**WEST SUSSEX COUNTY COUNCIL
PLANNING SERVICES CONSULTATION**

SUBJECT: LU/278/17/RES - Approval of Reserved Matters following Outline Permission LU/47/11 for Construction of the southern section of the Lyminster Bypass, including northern and southern roundabouts, surface water drainage and landscaping. Departure from the Development Plan and affects a Public Right of Way.

This is the second WSCC highways and transport response to the planning application for approval of reserved matters following Outline Permission LU/47/11 for Construction of the southern section of the Lyminster Bypass, including northern and southern roundabouts, surface water drainage and landscaping.

Roundabout at Northern end of Southern Bypass.

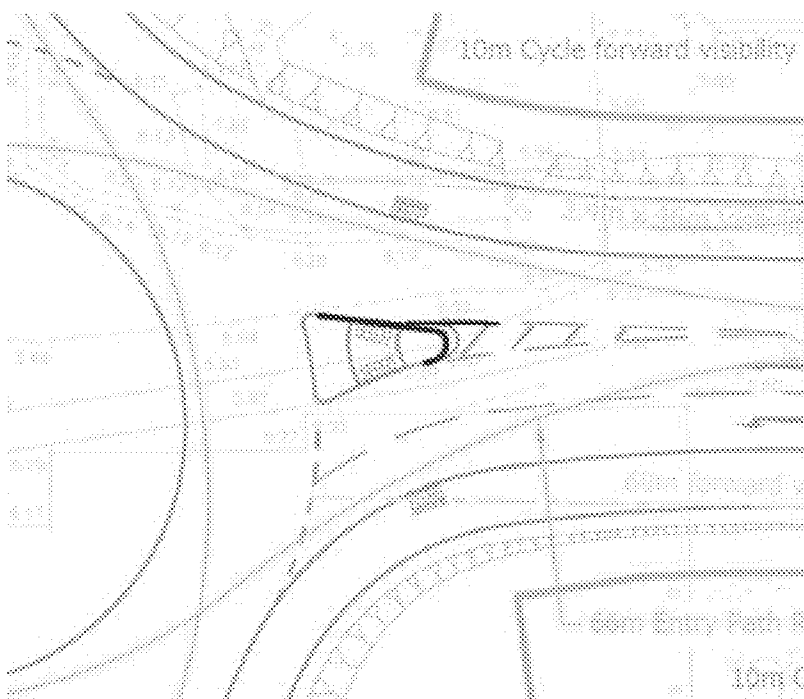
TD16/07 Para 7.61/7.62 Eastern Arm – Adjust width to 6m as per sketch. This will allow the road to be built and surfaced with TM to Chapter 8 of TSM.

TD16/07 Para 8.3 Eastern Arm – Departure application required.

A259/Worthing Road roundabout.

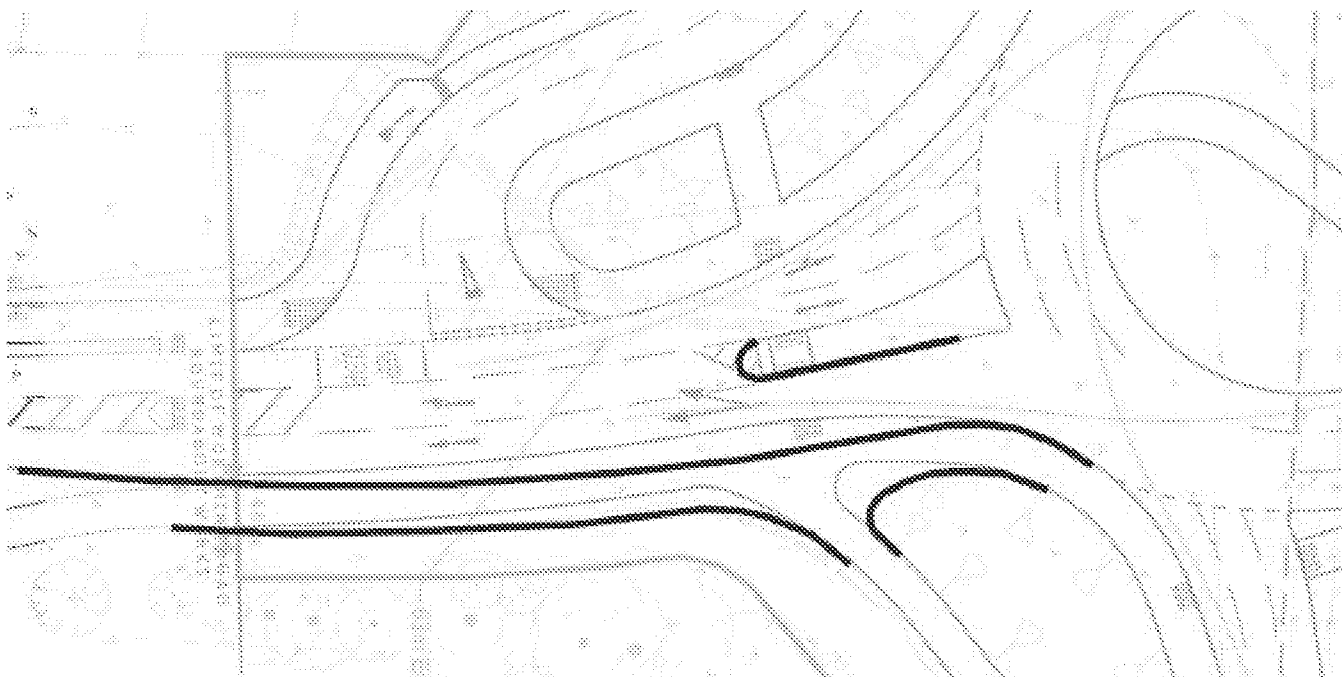
TD16/07 Para 7.61/7.62/7.63 Southern Arm – There is concern that the northern arm has 2 lanes marked for straight ahead movements with inadequate length to merge 2 in to 1 lane. Also on-road cyclists would be squeezed at this point. The width should be adjusted to 6m at the end of the island tapering down to 3.2m over about 75m – see sketch. Any revised drawing should be presented by the applicant to the Road Safety Audit Team for further comments.

MB Drawing A/PHLYM.1/ST-2/P8 Worthing Road Roundabout Surface Treatment

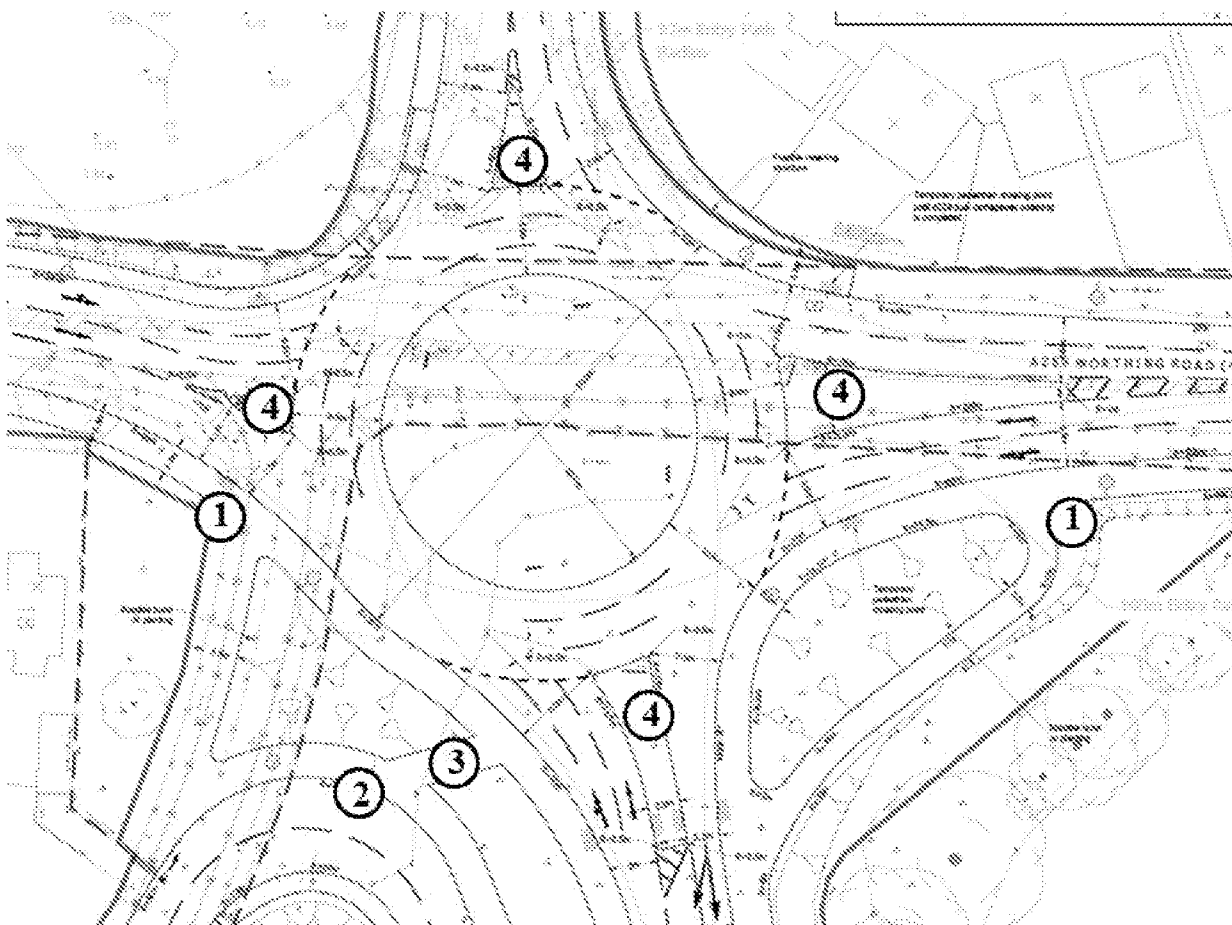
1. Sweeten cycle path radii and alignment.

2. Consider placing a dropped kerb on the desire line.

3. Align path with relocated crossing point

4. Beyond the footway width these islands need to be surfaced in colour contrasting material, such as in situ concrete or concrete pavements.

Applicant has responded saying that the cycle path alignment on western side of junction realigned to provide a smoother alignment using a 4m radius as requested and as discussed with WSCC (David Lambert - 20/11/17). In relation to the cycleway junction on the eastern arm, this was previously shown smoother but it was previously requested to straighten the alignment up to discourage high speeds along this section of path. A radius of 4m has thus been provided (the minimum inner radius recommended by LTN 2/08).

Applicant has responded saying that dropped kerb and hazard warning paving provided as requested. Will be checked at S38/278 stage.

Applicant has now realigned the path as requested.

Applicant has amended this and concrete to be provided as requested.
